**Before the Panel Convener appointed under the
Fast-track Approvals Act 2024**

In the matter of Mt Welcome, Pukerua Bay

Response to Panel Minute 11

28 August 2026

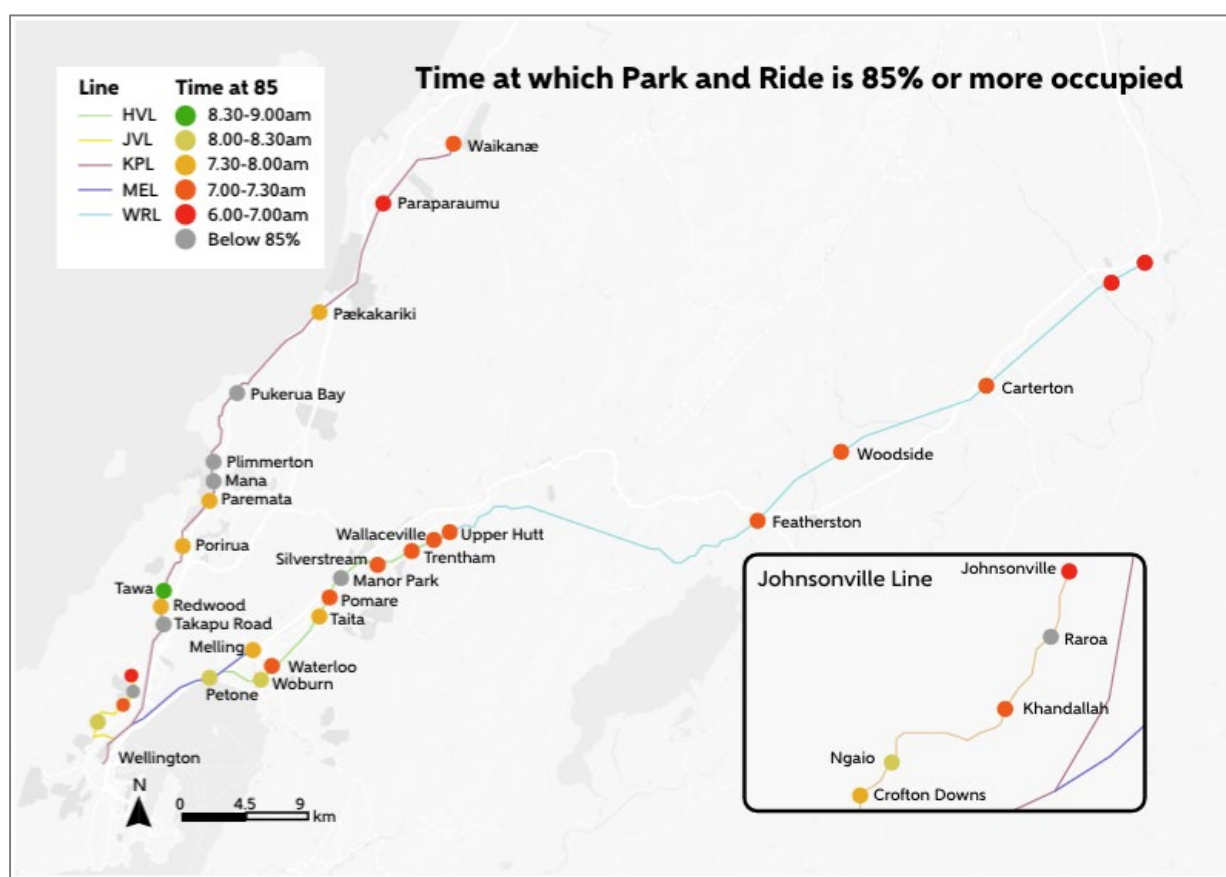
- (iii) In relation to section 7.3, is the active mode connection to Pukerua Bay and the Railway Station dependent on the Muri Block development being completed? If so, what is the fallback if that doesn't happen?*

The proposed shared path connection between the Site and the rail station is intended to be provided via the Muri Block land to the north. This approach reflects the constraints associated with providing a direct connection across State Highway 59 under the current 100km/h speed environment, which prevents a safe at-grade pedestrian and cycle crossing that would link with the Ara Harakeke shared path on the western side of the Highway. The connection via the Muri Block land therefore provides the most practical opportunity to achieve a connected active transport link to the rail station. While the ultimate delivery of this active mode route is dependent on the progression of development within the Muri Block, the land is being actively developed with initial stages consented and under construction.

Notwithstanding, the proposed Site earthworks design has been developed to preserve a potential alternative connection. Specifically, sufficient corridor width is available along the eastern side of SH59, extending from the proposed Site access roundabout to the northern Site boundary (approximately 220m), to accommodate a future shared path. Should the Muri Block connection not eventuate, this would provide the basis for an alternative active mode connection extending north along the eastern side of the Highway (rather than crossing it) to Gray Street / Taumata Road. The Applicant understands that Council and NZTA are preparing a Transport Masterplan for this SH59 corridor in consideration of responding to the Northern Growth Development Area, and that delivery of such a connection could form part of this planning.

Accordingly, the active mode connection is not reliant on a single outcome, and a potential alternative corridor can be achieved as an extension of the proposed Site access roundabout should the preferred Muri Block connection not proceed.
